WANNER™ HYDRA-CELL® PRO

Technical Bulletin TB0089

SUBJECT: Updated Q155 main bearing retention

Pump Models Affected: All Q155 Wanner™ Hydra-Cell® pump models.
– All pressure ratings.

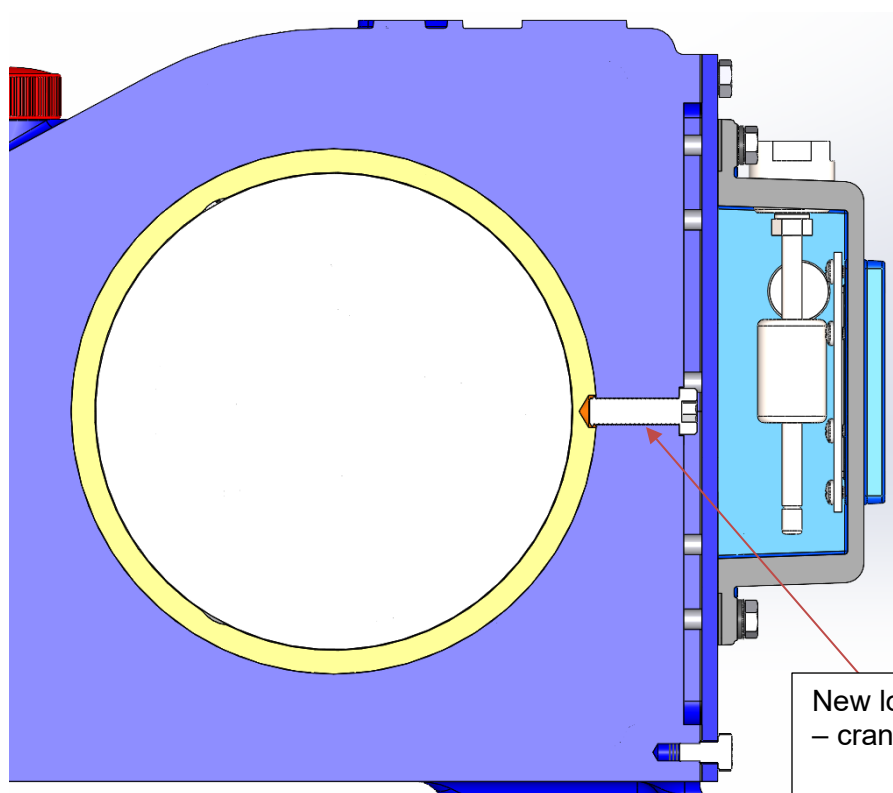
Two 177-118 set screws used to hold 209-041 main bearings are being replaced with 209-042 low-head cap screws. The torque required is 50 ft-lbf (68 N-m) with Loctite 242.

New low head cap screw replaces set screw
– crankcase is backwards compatible
